SERVICE – BULLETIN

Reference-N°: KTSE - SB - 2105

Unload Lever Lock Adjustment

| Model | Serial N° |
|---------|---|
| KX060-5 | See list at the end of the bulletin |

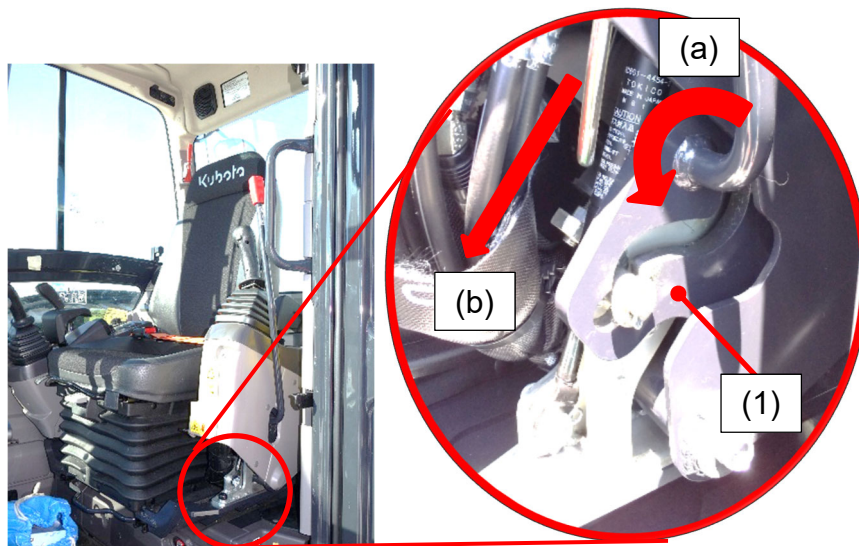
Cases of incorrect working unlock lever locks have been reported. Investigation revealed that the stopper bolt of the unlock lever mechanism was not correctly adjusted during the production. Normally, the unload lever link (1) unlocks the lever lock system in two steps:

- (a) Lower the unload lever
- (b) LH console lowering

Due to the misadjustment of the stopper bolt, the step (a) can be skipped on some machines. As countermeasure, the installation and adjustment process were improved.

Step 5:

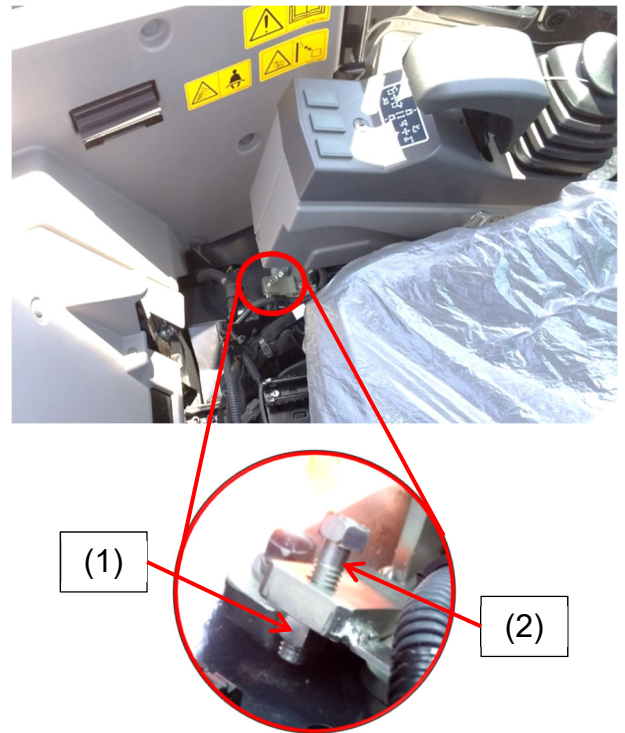
Loosen the lock nut (1) of the stopper bolt (2).

Step 6:

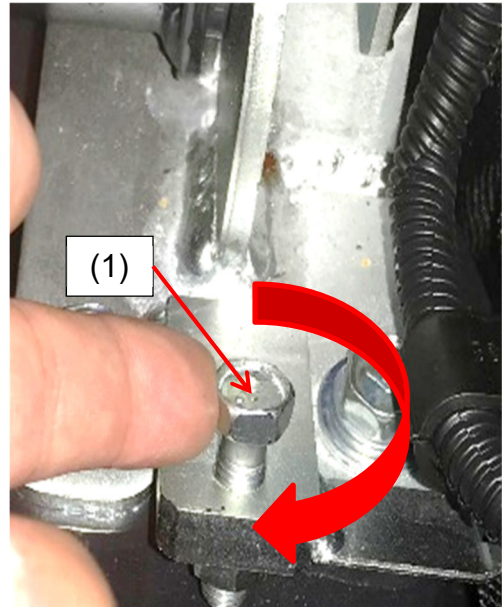
Screw in the stopper bolt (1) half a turn clockwise.

Repeat the steps 1 and 2. If it is still possible to lower the LH console by pushing the LH pilot lever forward, proceed with steps 4, 5, and 6.

If the LH console cannot be lowered anymore by pushing the LH pilot lever forward, proceed with step 8.

Step 9:

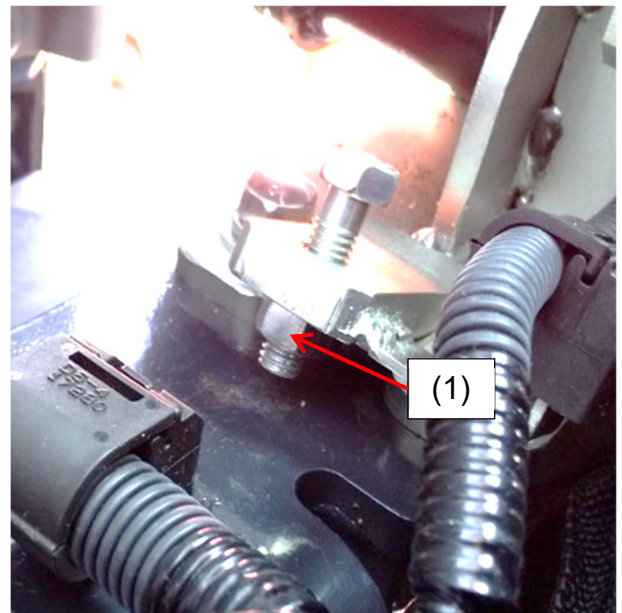
Tighten the lock nut (1).

Do not rotate the stopper bolt when tightening the lock nut.
